## **Response to Appendix A of Shared Spectrum's Reply Comments**

ET Docket No. 03-237

Dr. Jay E. Padgett  
Telcordia Technologies, Inc.  
Applied Research  
Wireless Systems and Networks

September 22, 2004

**Figure 8:** Figure 6 from [1].

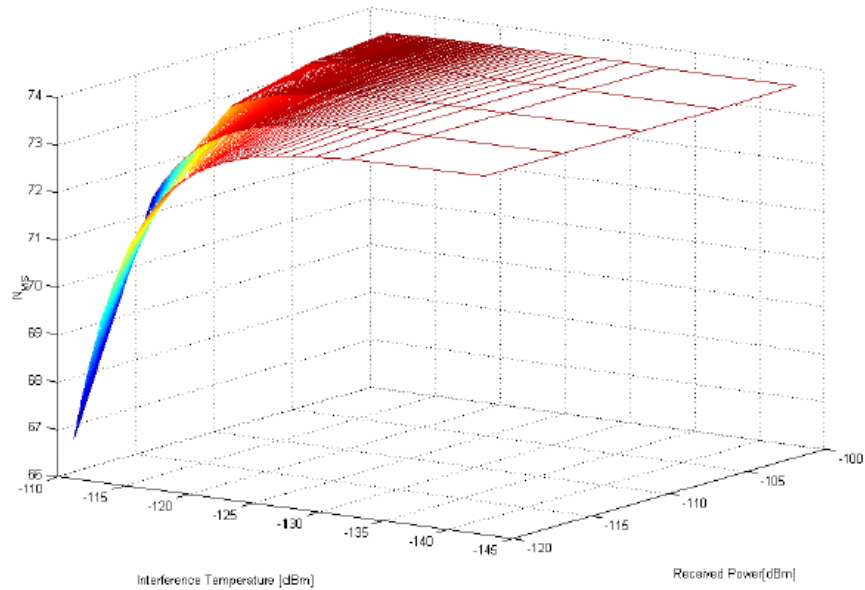
The capacity results provided by Shared Spectrum are demonstrably incorrect if cell coverage is maintained constant. It is unclear what parameters were used in generating the numerical results presented by Shared Spectrum, including  $P_n$ ,  $s_f$ ,  $\eta_f$ , and the allowable noise rise at the base station receiver. However, the range used for the “interference temperature” axis in Figures 6 and 7 of [1], coupled with Shared Spectrum’s reference to an interference temperature 15 dB above the noise floor, suggests that Shared Spectrum used the incorrect noise floor. With a bandwidth of 1.25 MHz and a 4-dB noise figure, the noise floor ( $P_n$ ) would be about  $-109$  dBm. The upper end of the “interference temperature” axis is  $-110$  dBm, which is 1 dB below the noise floor rather than 15 dB above it. Moreover, Shared Spectrum states:

In Figure 6, the system capacity remains 73 while the Interference Temperature is increased from  $-135$  dBm to  $-120$  dBm. Similarly in Figure 7, we have noticed that the CDMA system capacity is unchanged while the Interference Temperature ranges between  $-135$  dBm and  $-115$  dBm. ([1], p. 15).

This passage suggests that Shared Spectrum used an incorrect value for the noise floor, perhaps about  $-135$  dBm. With such a low noise floor, the received signal power values ( $-120$  to  $-100$  dBm) shown represent relatively high power levels, corresponding to greatly reduced coverage, as can be seen by comparing Figure 7 and Figure 8. Shared Spectrum’s capacity analysis is therefore unrealistic, and would require a large sacrifice in coverage.
